**ADDENDUM TO BID
7TH STREET LIGHTING PHASE II - 2016
BID NO.: 316-PW-030**

ADDENDUM NO.: 1

Project Name: 7th Street Lighting Phase II

SHEET 09 OF 42 SHEETS

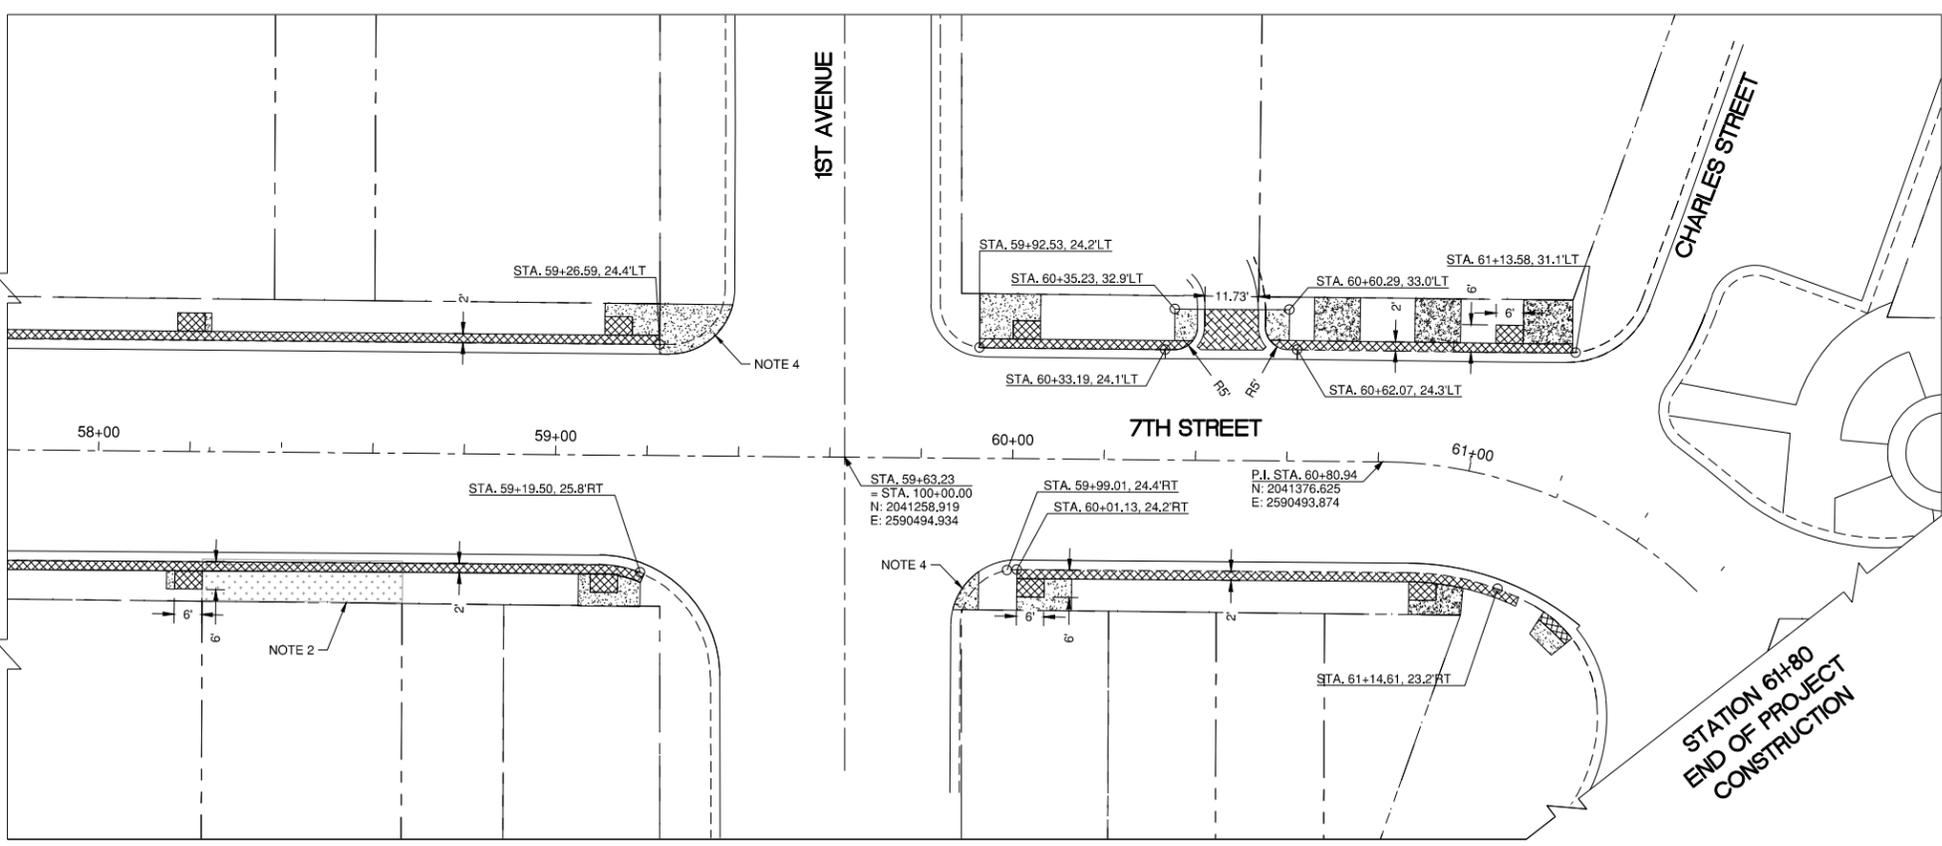
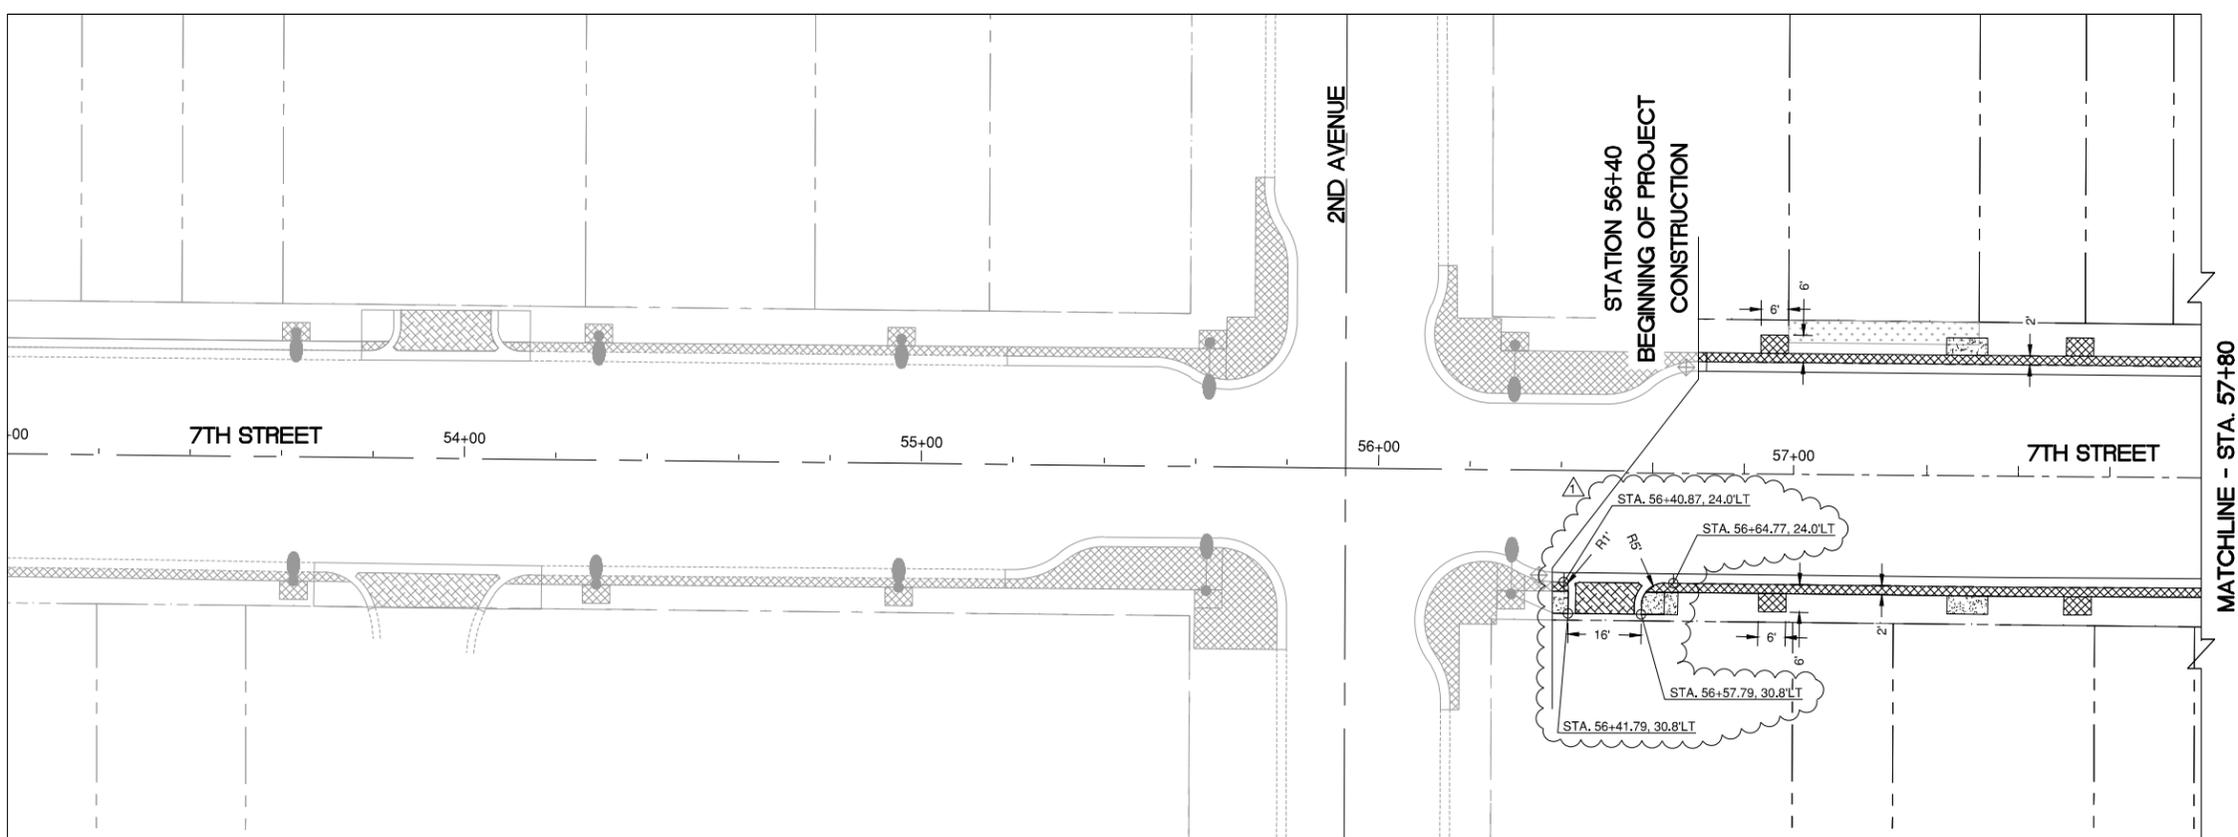
SHEET 09 – ROADWAY PLAN

1. Add the driveway at Lung Fung.

SHEET 29 OF 42 SHEETS

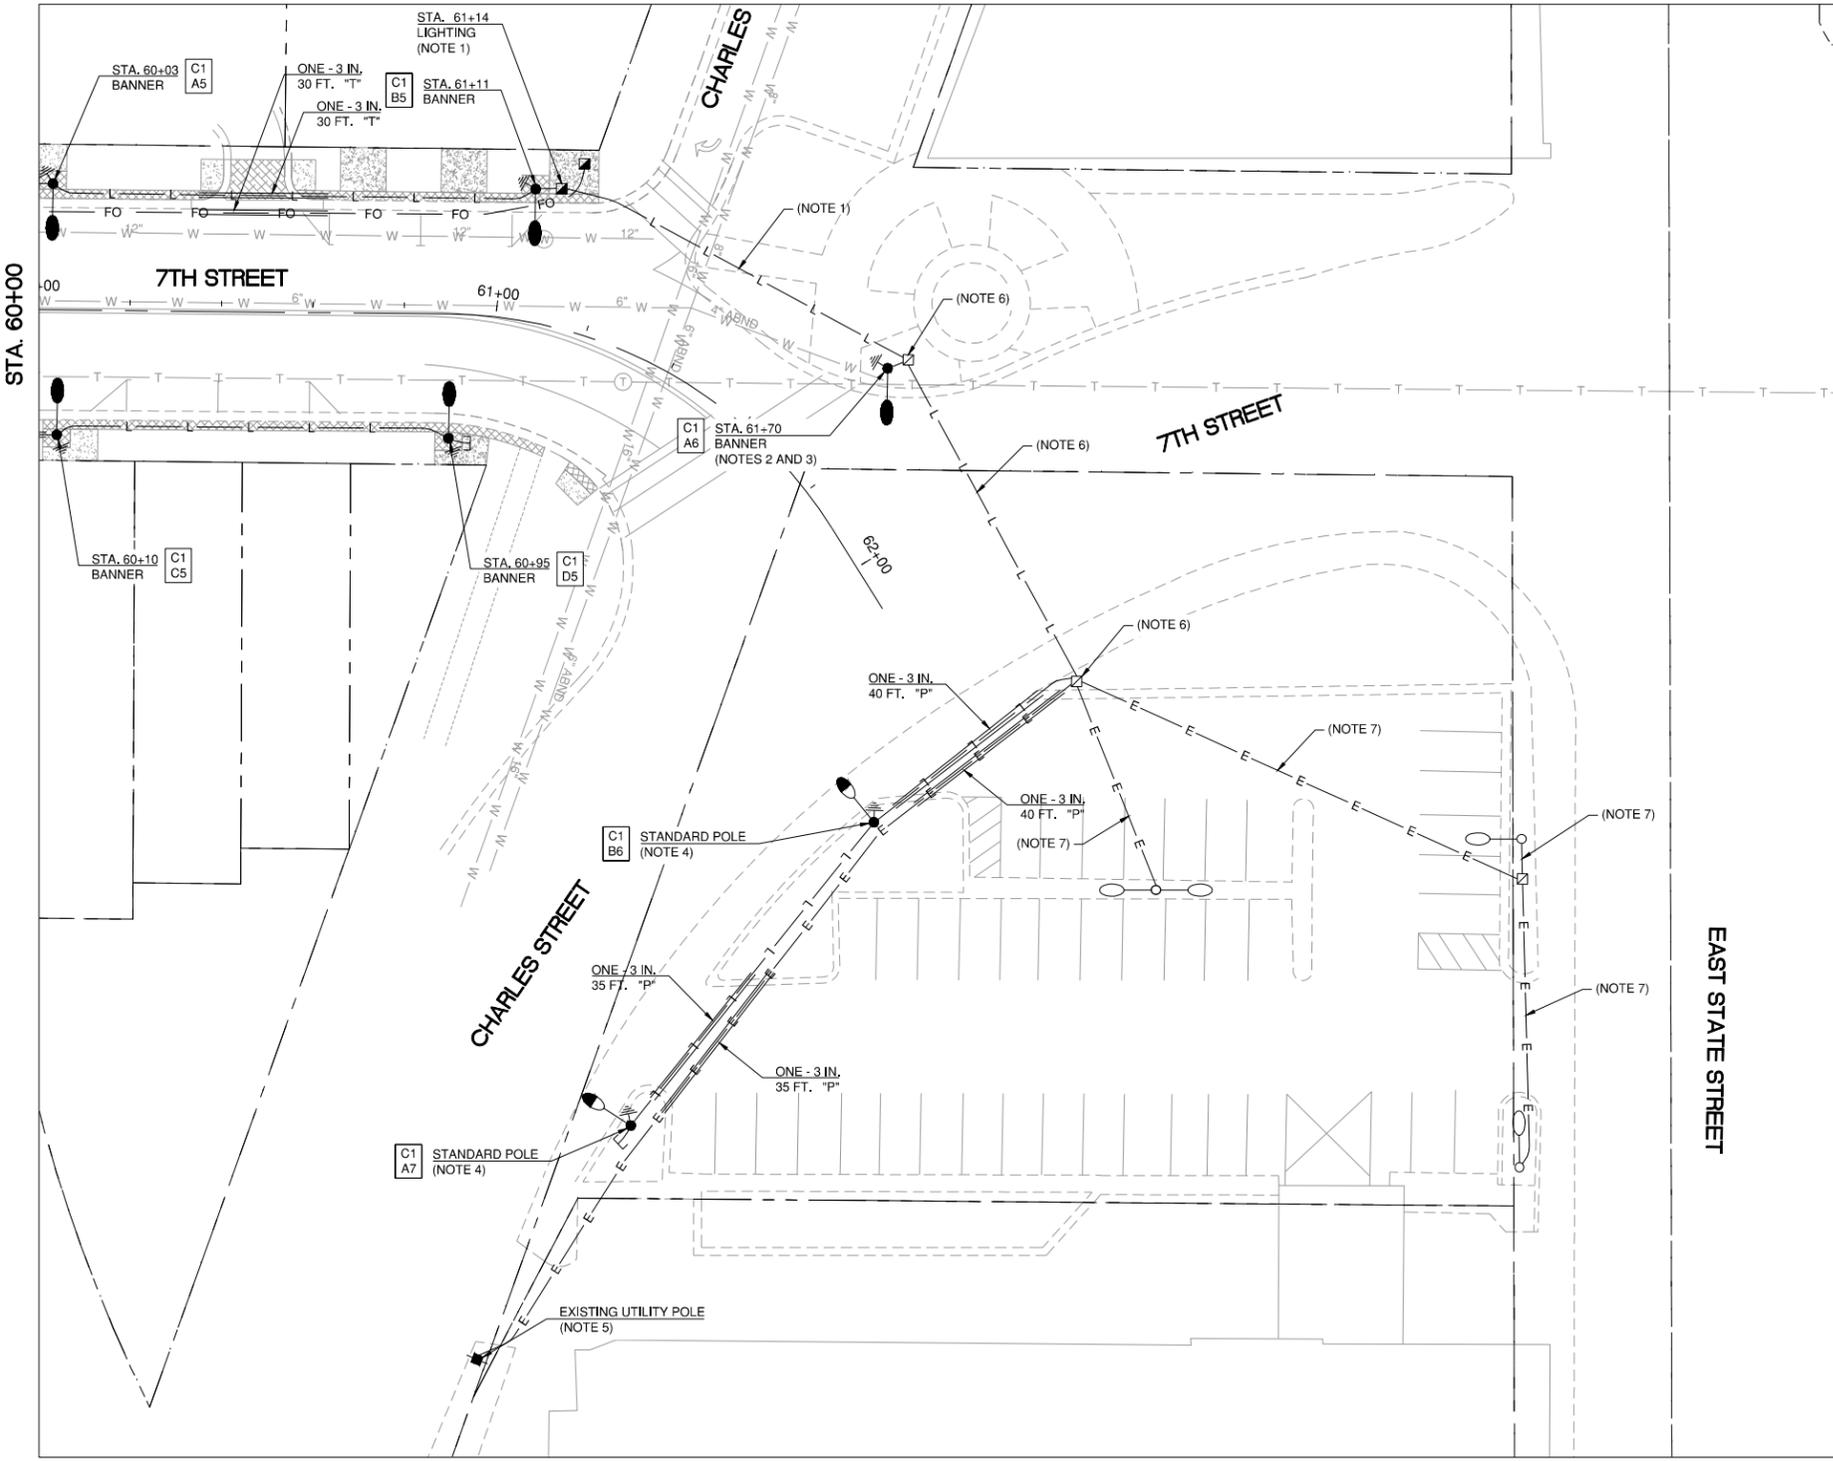
SHEET 29 – ROADWAY LIGHTING PLAN

1. Add the catalog information for the LED Cobra heads.

- LUMINAIRE SHALL BE A LUMEC ROADFOCUS LED COBRA HEAD (MEDIUM), CAT# RFM-72W32LED4K-T-R3M-UNIV-DMG
